## RPRC RETURN LETTER

Application Number: 2021-0980

Street Location: 45 BYRAM RIDGE RD

**Re: 45 Byram Ridge Rd – Section 101.03 Block 3 Lot 24**

**ZONING PLAN**

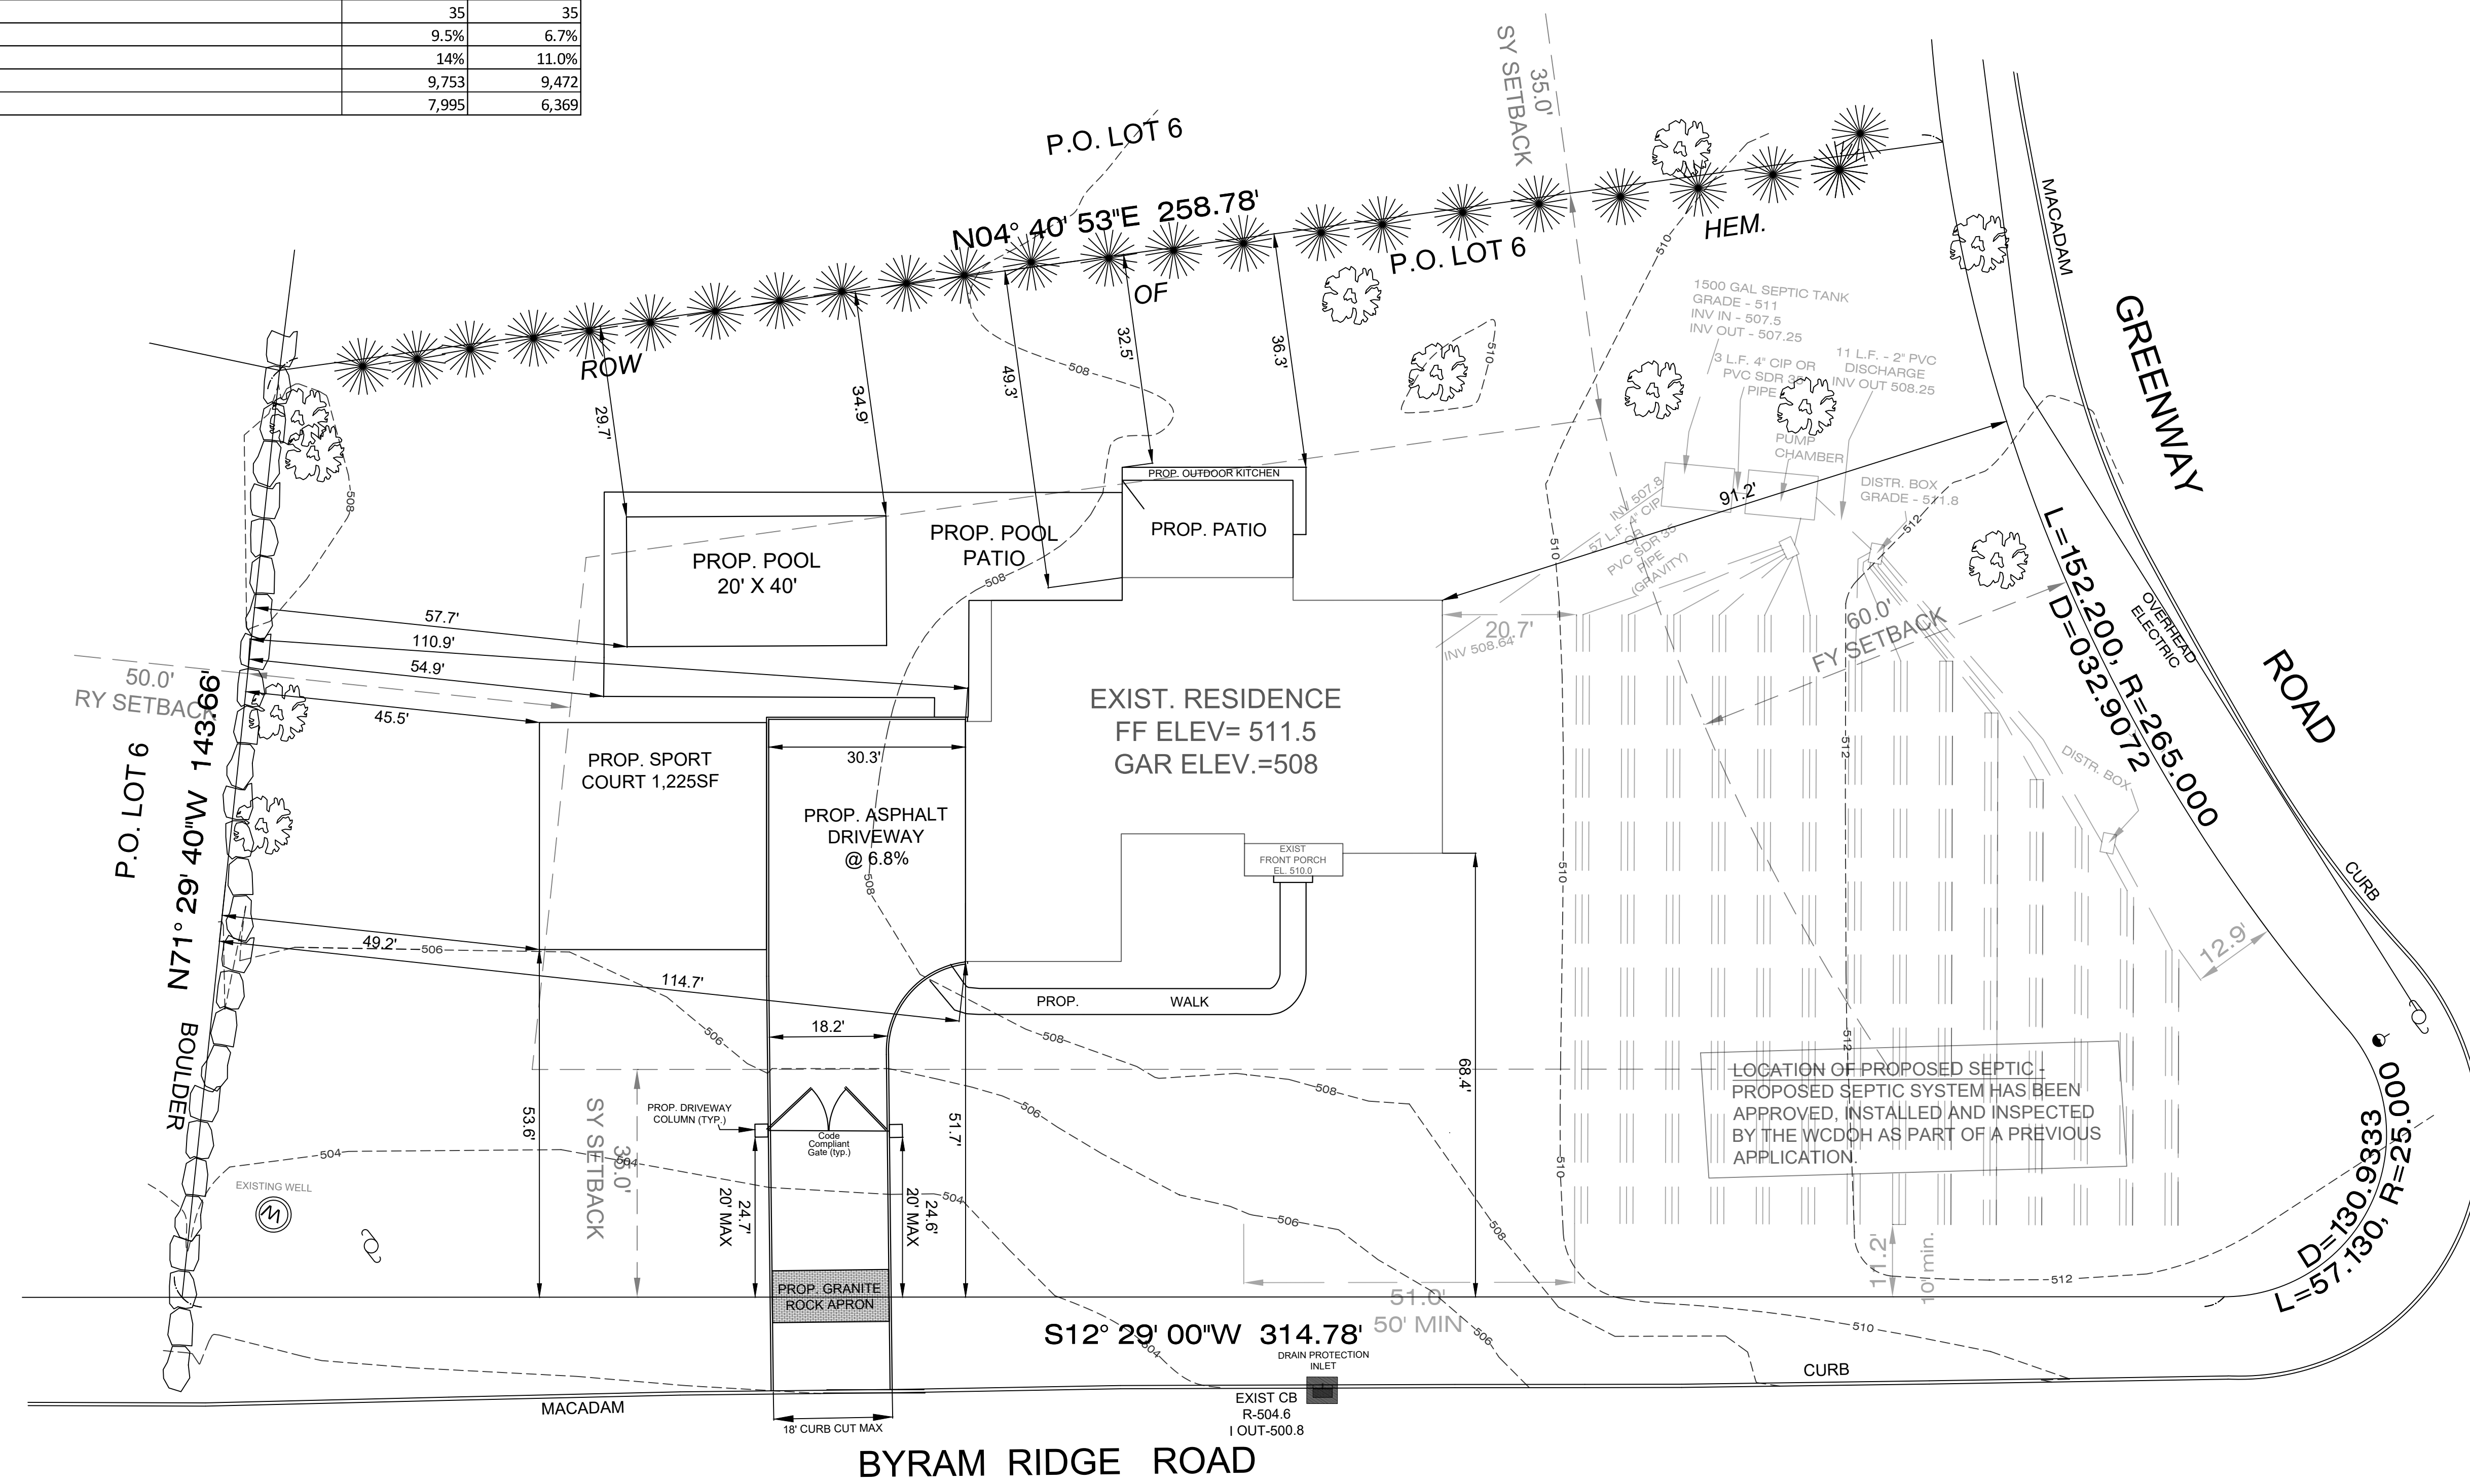
- The site plan should be revised to include a zoning conformance table and depict the distance from all proposed structures to adjacent property lines.

- **All proposed structures display distance to the property line according to the zoning conformance table.**
- The site plan should depict any proposed Town-regulated tree removal. If none is proposed, a note stating such should be added to the plan.

**STORMWATER & GRADING PLAN**

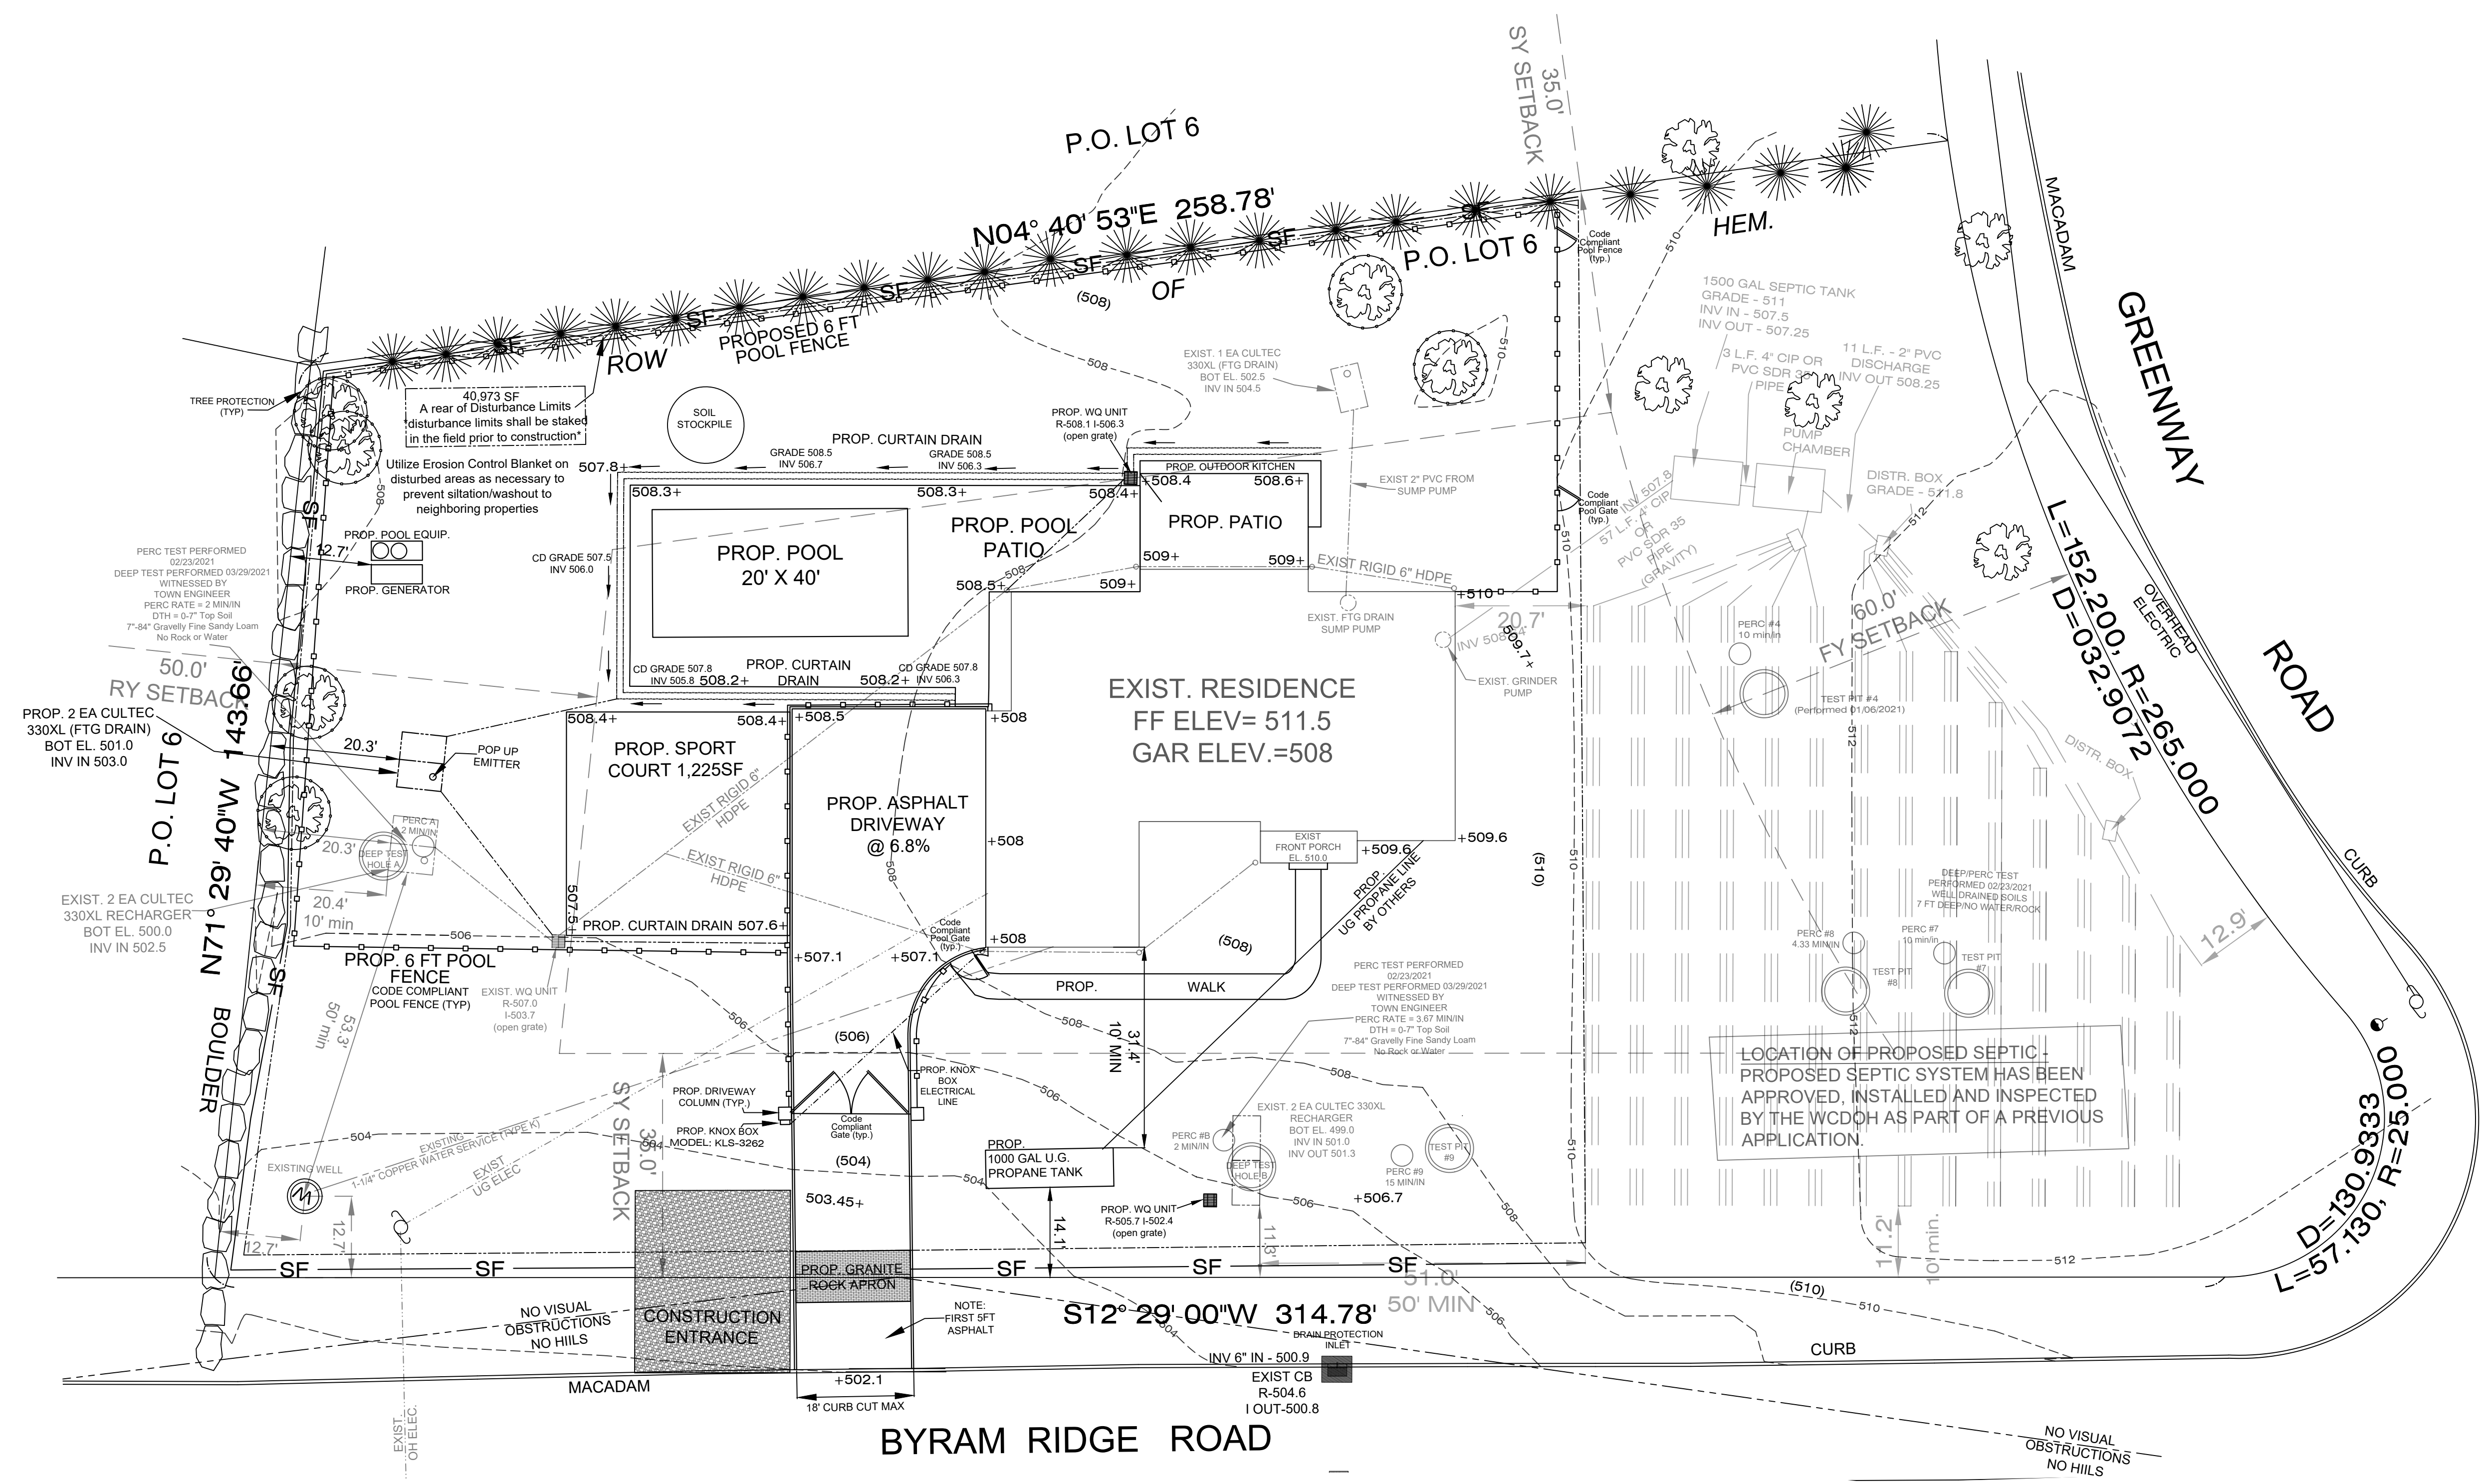
- Clarify the pool deck drainage collection system.

- Provide stormwater mitigation design calculations for the runoff generated by the net increase in impervious surface for the 25-year, 24-hour design storm event or a six (6) inch pool drawdown volume; whichever is greater. Provide details of the stormwater mitigation system. Please clarify the existing treatment system and proposed mitigation.

- The plan shall illustrate the connection between the pool equipment and drawdown mitigation practice.
- The plan shall illustrate the roof drain (pool house) and drainage pipe connections on the site plan. Include the size, slope and material. Provide outlet protection details.

- Include erosion control measures on the plan, including, but not limited to, temporary construction access, silt fence, erosion control blanket, inlet protection, construction sequence, etc. Provide details.

- There are now separate plan sheets clarifying existing and proposed improvements.
- Clarify the pool deck drainage collection system.
  - Stormwater plan now shows drainage collection system capturing entire pool deck area.

- Stormwater mitigation design calculations are shown on the detail sheet. The runoff generated from a net impervious surface of 3,062 SF is 5.45 inches. With a pool area of 800 SF and a 6 inch pool drawdown depth, the total storage needed for the pool drawdown is 400 CF; The additional impervious is 1,646 CF.

- The plan shall illustrate the connection between the pool equipment and drawdown mitigation practice.
  - Stormwater plan now shows the connection between the pool equipment and drawdown mitigation practice.

- Pool house has been removed from stormwater plan however, existing drainpipe connections will be shown on the stormwater plan.
- Include erosion control measures on the plan, including, but not limited to, temporary construction access, silt fence, erosion control blanket, inlet protection, construction sequence, etc. Provide details.

- Erosion control measures are shown on the stormwater plan which include, a silt fence, erosion control blanket, inlet protection, and a construction sequence to all disturbed areas preventing siltation/washout to nearby areas.
